1. Background to the Easton Estate

File Ref: JB/JPC/P21-2417/01TN – Easton Estate

Subject: The A47 North Tuddenham to Easton Development – Deadline Submission Noise

Figure 1: Proposed A47 Dual Carriageway and Easton Estate

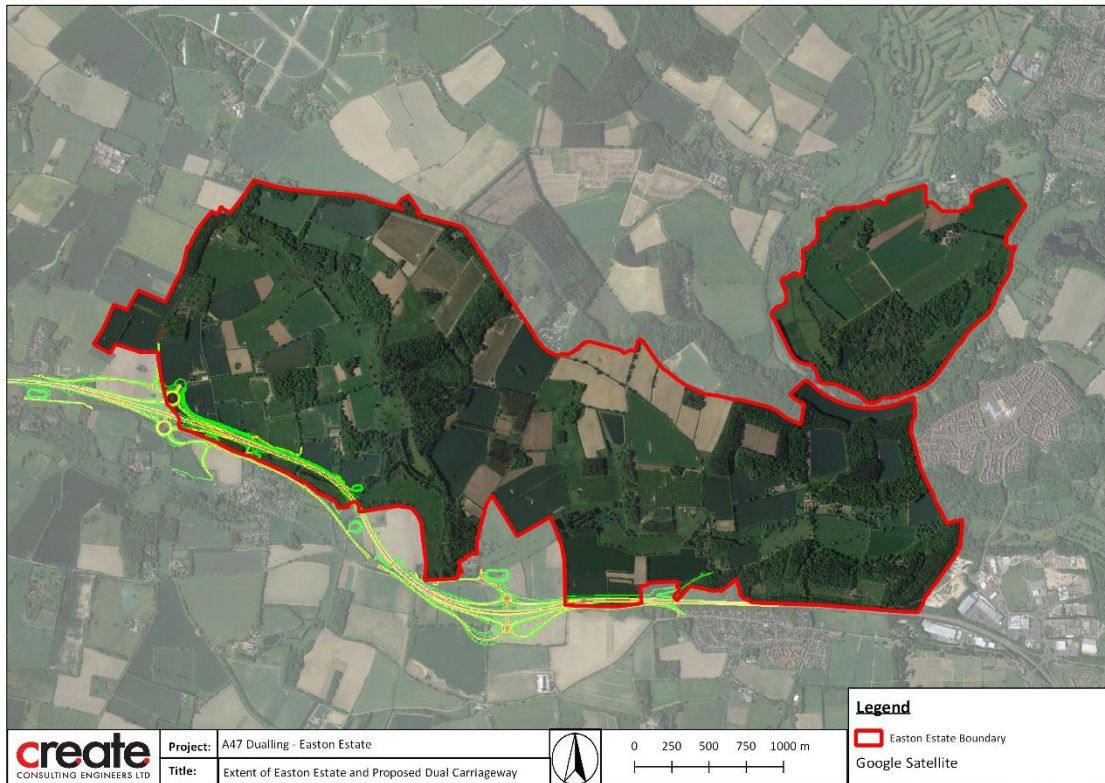
- 2.1 In summary, Create would like to highlight the following points.
- 2.2 The proposed A47 dual carriageway is within close proximity to the Easton Estate and encroaches at some points as can be seen on the following diagram.

Figure 2: Excerpt of Figure 11.8 From Appendix 6.2 Overlaid With Estate Boundary

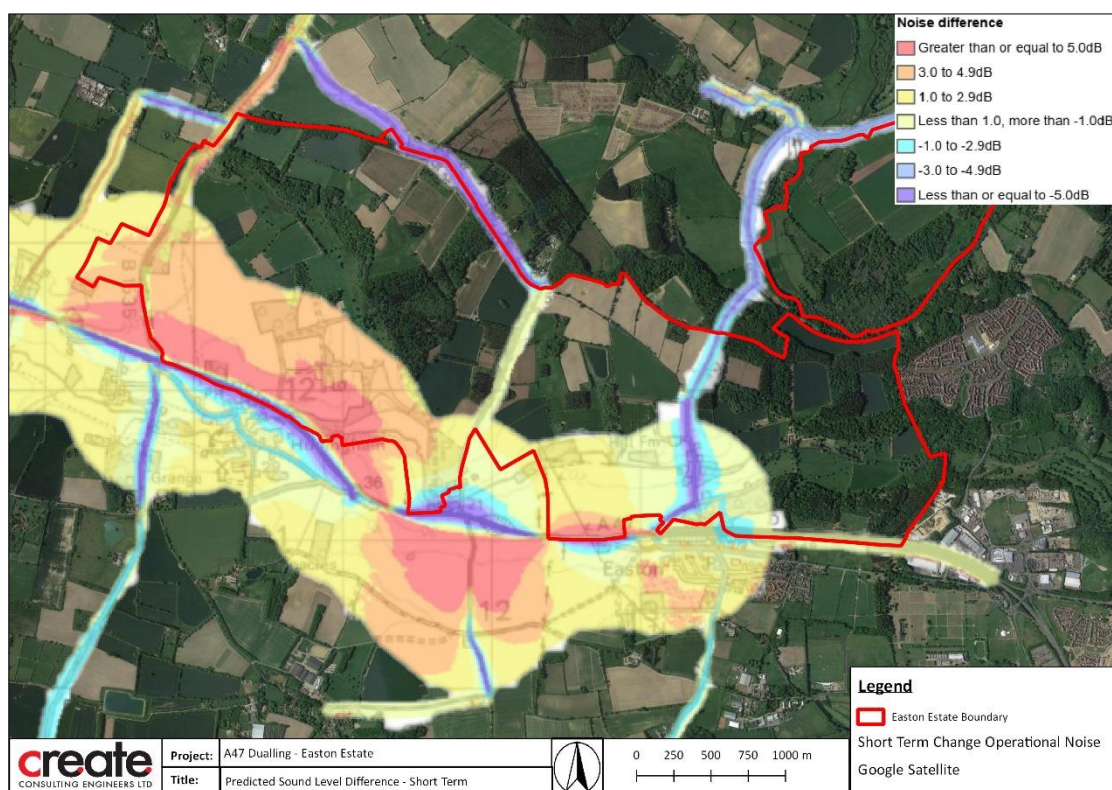
- 2.6 The operational sound levels should be considered against the existing acoustic climate. This is particularly apparent for properties and roads which are away from the main dual carriageway, but would be used as access routes for local traffic or for diversion routes. The noise model prepared by the applicant has shown that these increases in both the short and long term would be significant.
- 2.7 We have overlaid the short-term noise difference contour for the proposed scheme onto an aerial image of the estate to illustrate how the increase in sound levels will impact upon a large degree of the estate.

- 2.8 Although the majority of the site has been shown to be “Minor or Negligible” it is important to highlight that the calculation area has been restricted to that shown in Figure 2. The proposed usage of Wood Lane would increase the sound levels dramatically for the properties along this route which have been constructed in close proximity to the roadside.
- 2.9 The proposed mitigation does not appear to include any mitigation for this estate, other than low noise road surfacing. The general topography of the site would suggest that the more typical earth bunds and / or acoustic barriers may prove problematic to install, however there are suitable alternative options available to the applicant, other than the “blanket use “ of the Code of Construction Practice (CoCP) and Best Practicable Means (BPM). This is inherently

Figure 3: Predicted (Unmitigated) Construction Sound Levels for Stages 51 through to 65

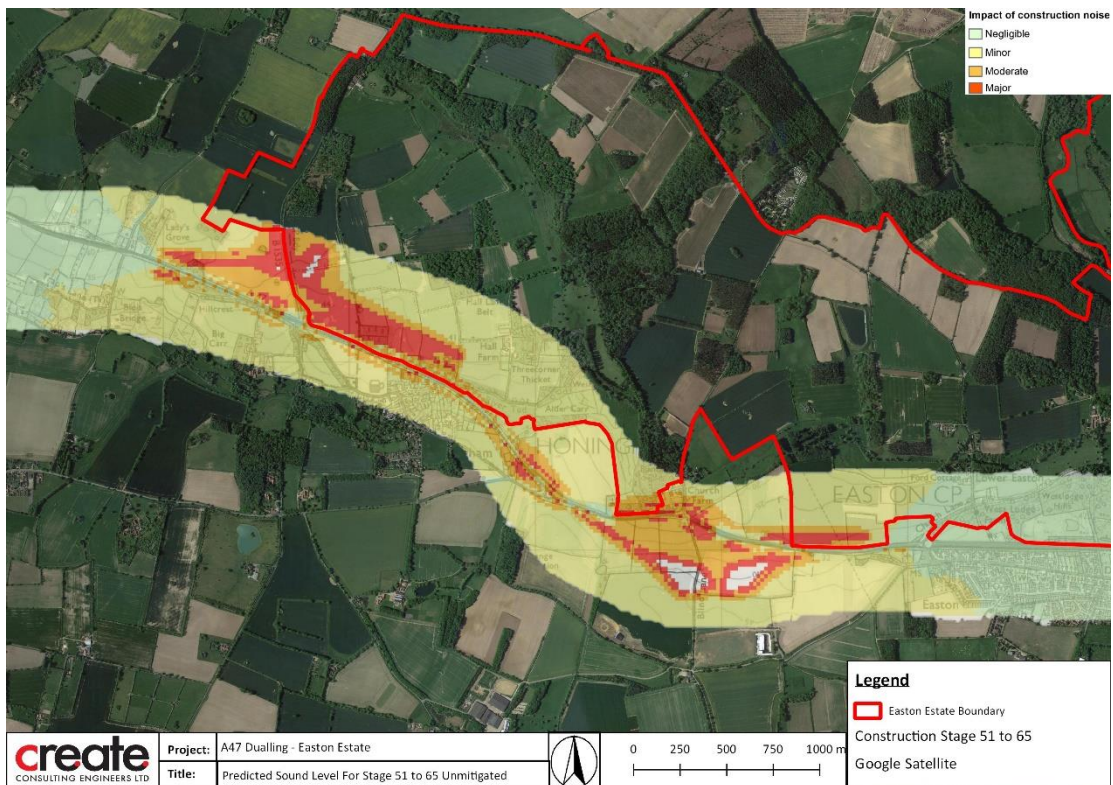
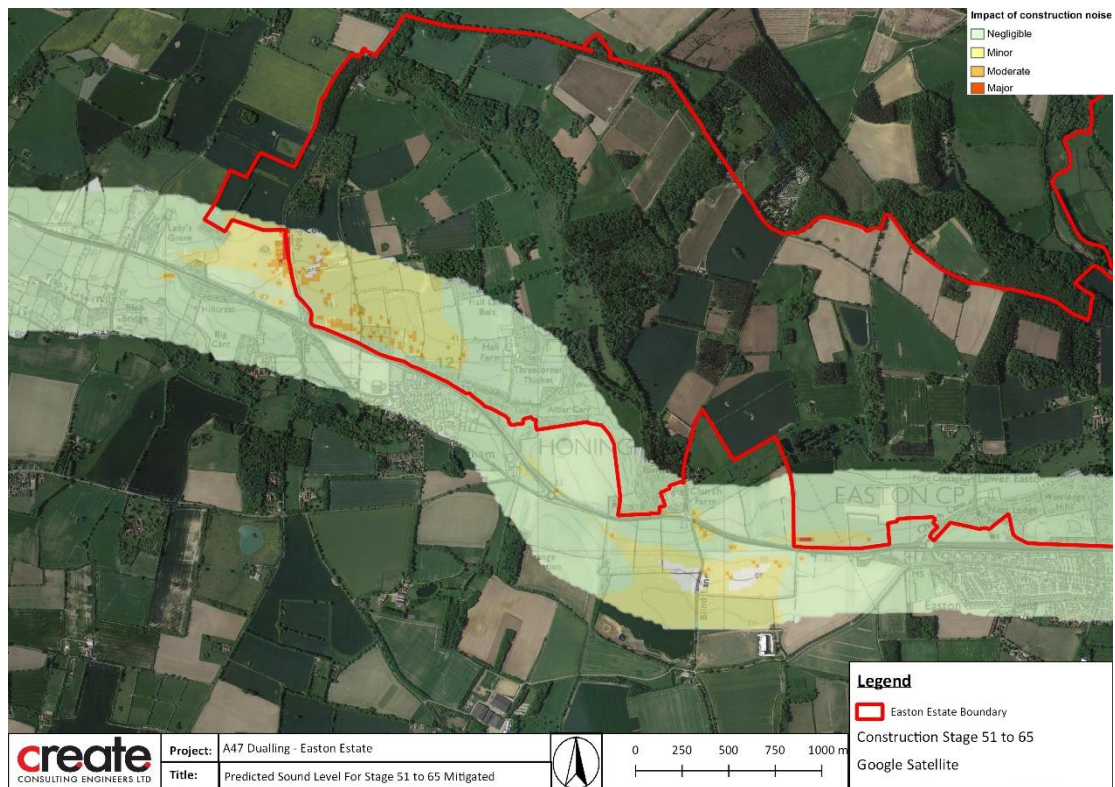
- 2.10 As can be seen in Figure 3, the proposed construction noise levels during the daytime along the southern boundary of the estate would clearly be audible and considered to be Moderate and Major in some locations. It must be noted that these levels are unmitigated. The mitigated sound levels have been shown in Figure 4.

- 2.11 Although Figure 4 shows a significant level of reduction, we are concerned as to the realistic reductions that have been modelled, primarily because the applicant appears to have relied upon the successful implementation and following of the CoCP and BPM techniques. These mitigative strategies have also been based on the assumed construction activities and would need to be recalculated once definitive method statements and RAMS have been prepared.

Figure 5: Predicted (Unmitigated) Construction Sound Levels for Stages 66 through to 69 During Night-time

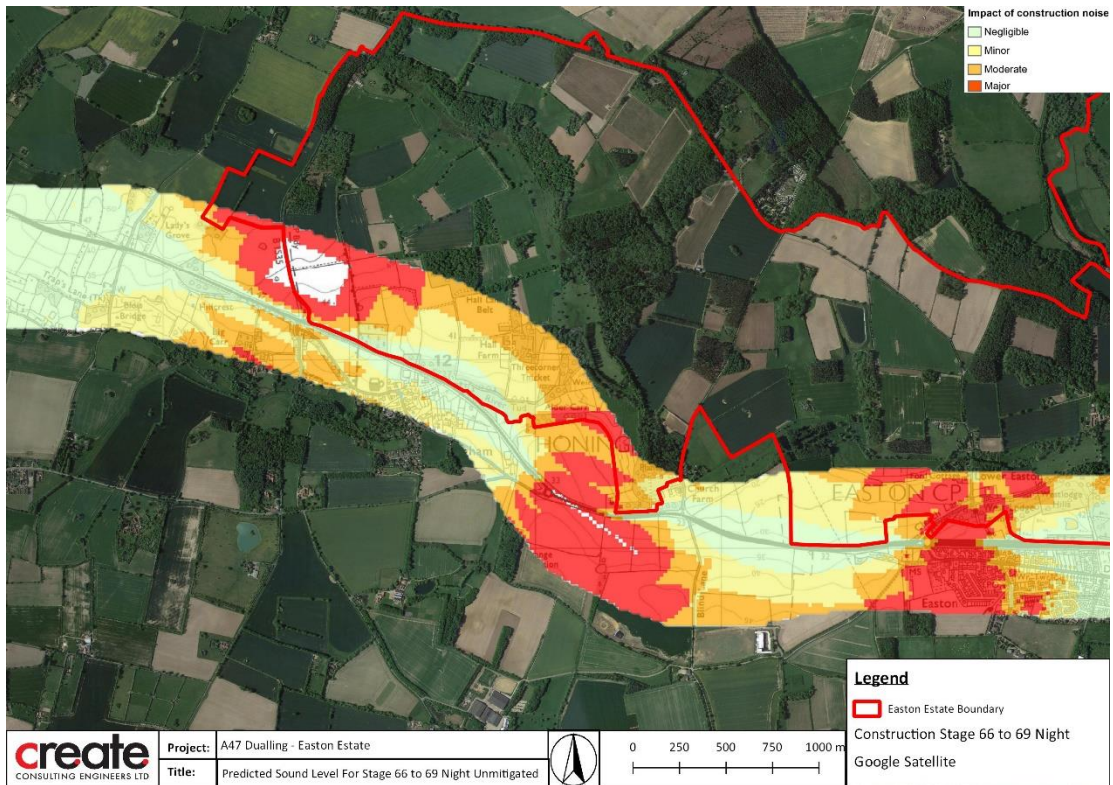
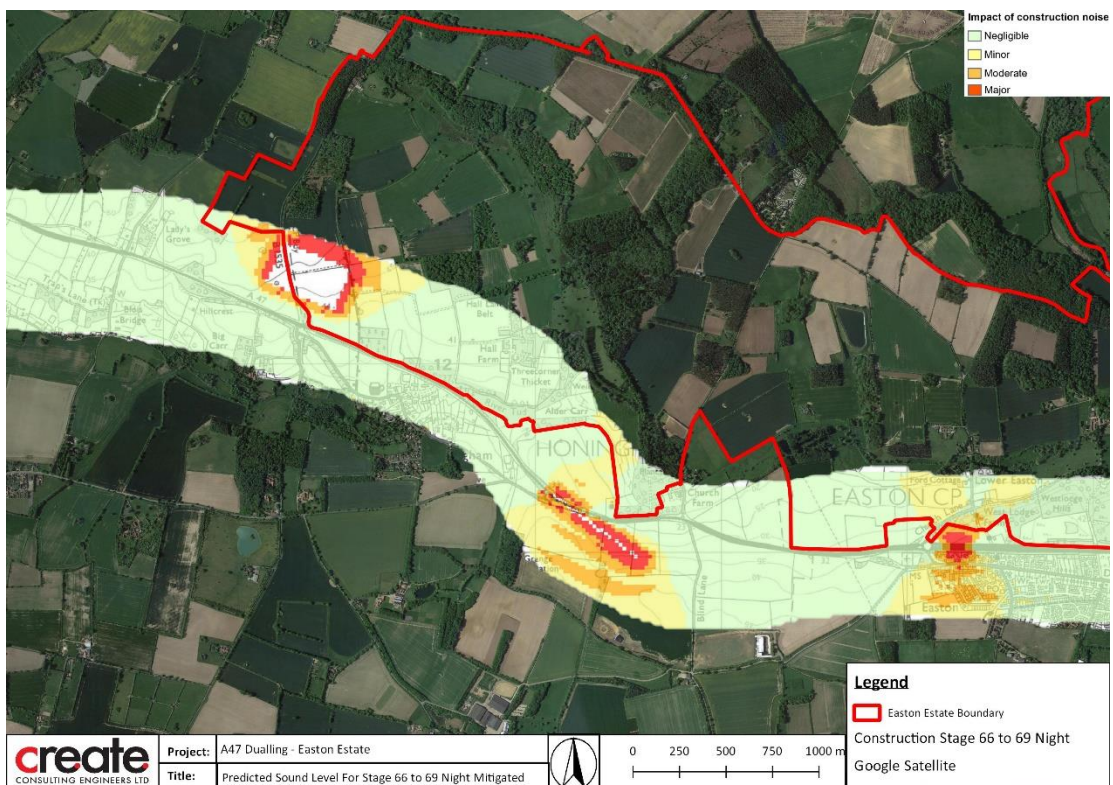
- 2.13 The night-time construction levels have been overlaid in the same manner as previous within Figures 5 and 6. Figure 5 shows the predicted sound level from stages 66 through to 69 during the night-time without mitigation and Figure 6 includes the same but once mitigated.

- 2.14 The night-time construction levels have been predicted to be considered to be Moderate and Major along the key areas at the southern aspect of the estate. Through the reliance on the CoCP and BPM, we have severe concerns that the sound levels would still be classed as being at significantly high levels.

- 2.15 We are seeking a full and conclusive construction noise and vibration assessment be completed once the method statements have been finalised and suitable noise mitigation be implemented to reduce the impact of the construction noise.
